POLARIS	<h1 style="margin: 0;">TECHNICAL SERVICE BULLETIN</h1>
Date: March 21, 2017	<h2 style="margin: 0; color: green;">ATV</h2>
Bulletin Number: A-17-01-A Model Years: 2015 - 2016	
<div style="display: flex; justify-content: space-around; align-items: center;"> <div style="border: 2px solid black; border-radius: 50%; padding: 5px; display: flex; align-items: center;"> <input checked="" type="checkbox"/> Safety Bulletin </div> <div><input type="checkbox"/> Service Bulletin</div> <div><input type="checkbox"/> Service Alert Fax</div> </div>	
Distribution: <input type="checkbox"/> Owner/Principal <input type="checkbox"/> Service Manager <input type="checkbox"/> Sales Manager <input type="checkbox"/> Parts Manager <input type="checkbox"/> Technicians <i>This Service Bulletin is located at www.polarisdealers.com</i> <small>- Confidential and Proprietary -</small>

SUBJECT:
2015–2016 Sportsman Touring 850/1000 Thermal Protection Update
PURPOSE:

To resolve this concern, a new exhaust manifold side panel has been developed. The new exhaust manifold side panel significantly increases the air gap between the exhaust manifold and exhaust manifold side panel and utilizes a metal heat shield.

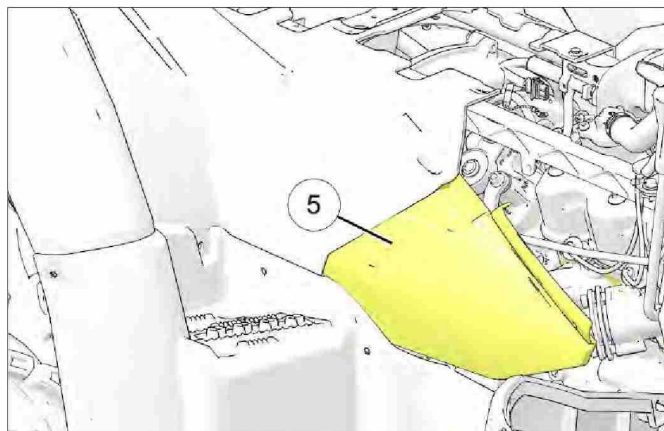
6. Remove the exhaust manifold side panel ⑤ and discard.

Pull the front edge of the rear cab away from the vehicle and slide the exhaust manifold side panel ⑤ forward to remove.

Discard the original exhaust manifold side panel at this time.

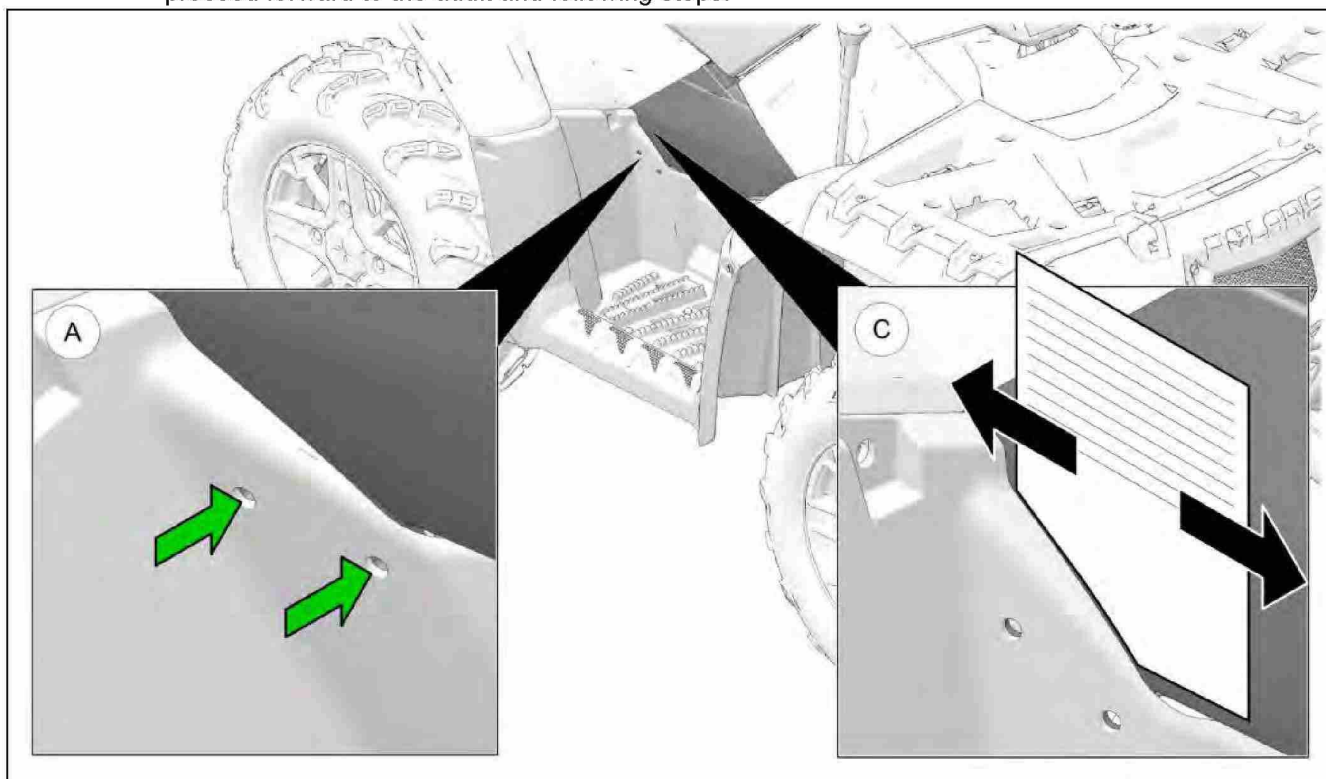
3. Place the provided template ① on the right-hand footwell ② as shown, then mark the perimeter of the template to outline the area to be trimmed with a paint pen.

Use the inside and back edges of the footwell to locate the template.

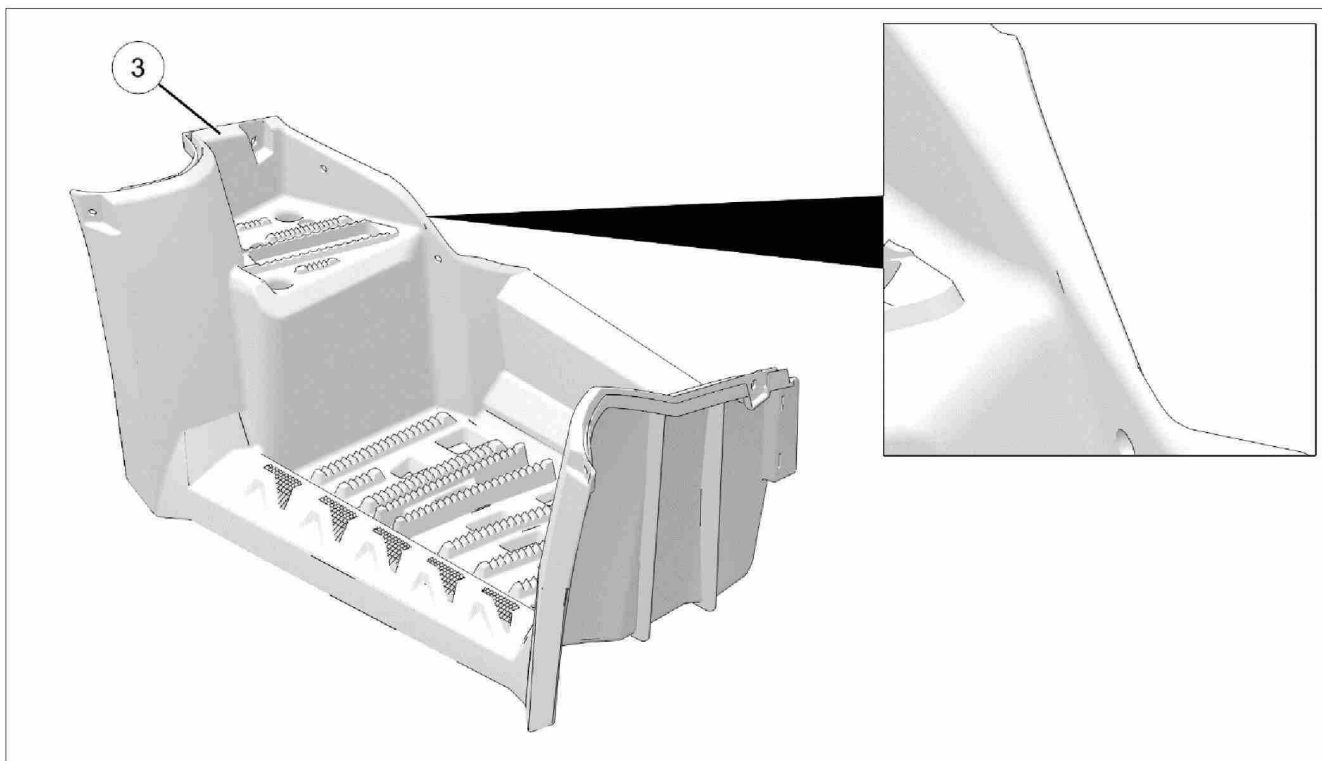
6. Test fit the new panel to verify the area trimmed area of the footwell does not contact the exhaust manifold side panel.
 - A. Align the exhaust manifold side panel mounting holes.
 - B. Apply pressure to the footwell at the mounting holes.
 - C. Slide a piece of paper along the gap between the two panels.
 - If the paper slows or stops or the metal shield makes contact with the footwell, use a half-round file to trim the footwell to create a clearance gap between the components.
 - If the paper freely travels the length of the gap, and the metal shield does not contact the footwell, proceed forward to the audit and following steps.

If a piece of paper does not freely slide between the panels, continue to trim the panel using a half round file until the paper passes freely the entire length of the gap.

7. Using a half-round file, file and deburr the trimmed footwell ③. Ensure the footwell is clean, free of burrs, and maintains rider appeal. Verify trimmed area appears as shown in the illustration below.

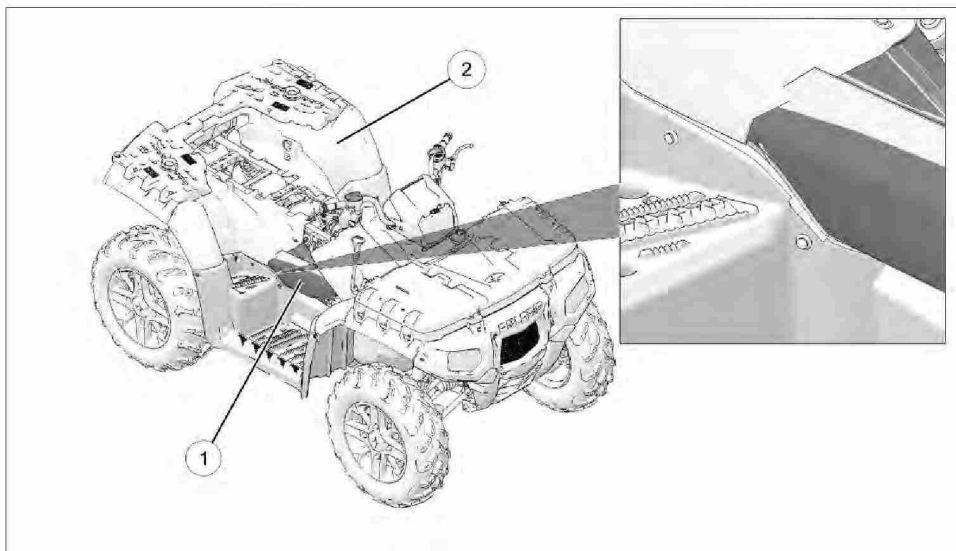
1. Install the NEW exhaust manifold side panel ① by lifting the front of the rear cab ② and pushing the NEW exhaust manifold side panel ① rearward along the head pipe.

A secondary dealer representative must verify that the new exhaust manifold side panel ① has been installed and the original exhaust manifold side panel has been discarded.

APPLICATION: SPORTSMAN 850 / 1000 TOURING

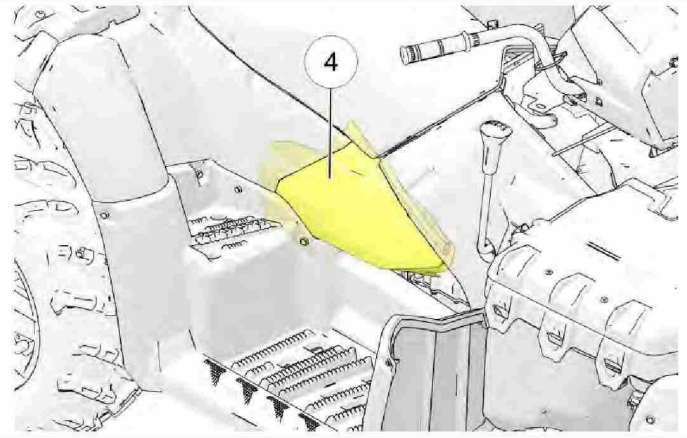
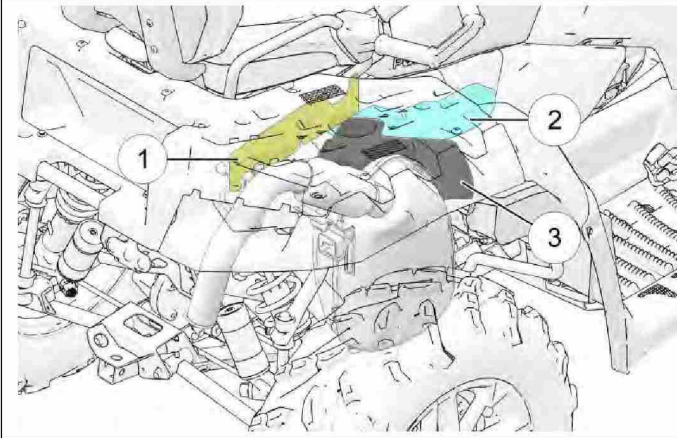
OLD HEAT SHIELD TO INSPECT		NEW HEAT SHIELDS TO INSTALL	
Use the checklist below to verify that the following shields are NOT removed and are in good condition. Be sure to check each box as you verify each shield has not been removed.		Use the checklist below to verify that the following NEW shield is installed. Be sure to check the box as shield installation is complete.	
<input type="checkbox"/>	① Exhaust Silencer Shield 5253634	<input type="checkbox"/>	② Exhaust Manifold Side Panel 2636626

PHOTO 1 - 1000 Touring

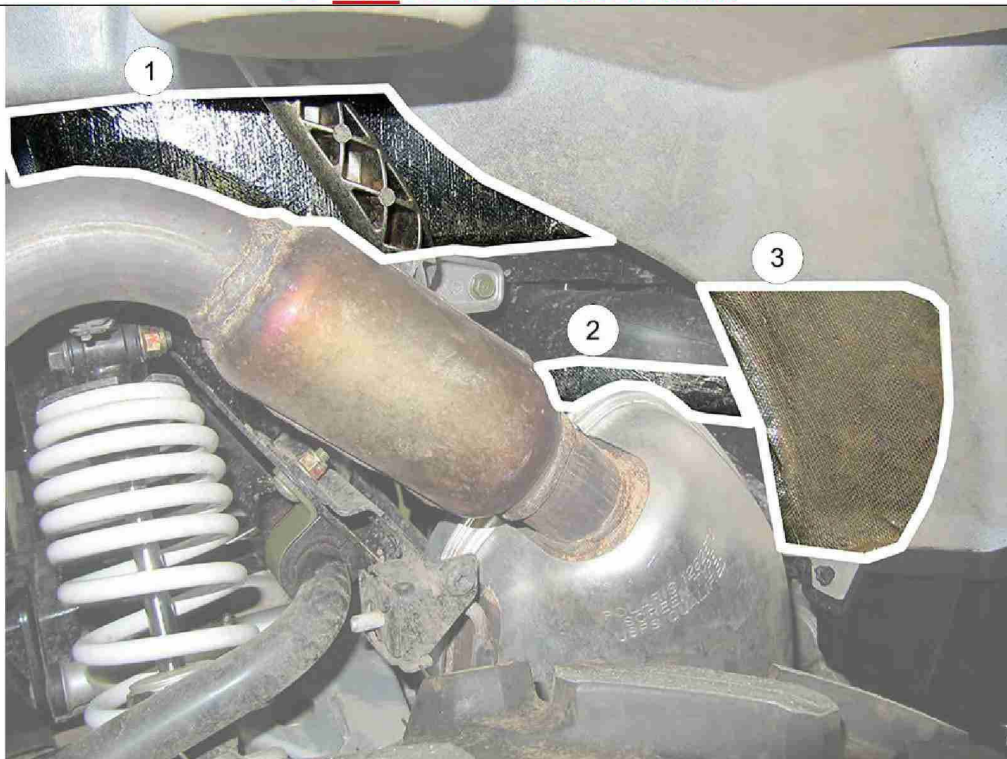
Do NOT remove these shields!

| ① Seatwell Foil Heat Shield | 5814246 |
| ② Clutch Duct Heat Shield | 5814214 |
| ③ Rear Cab Foil Heat Shield | 5814215 |
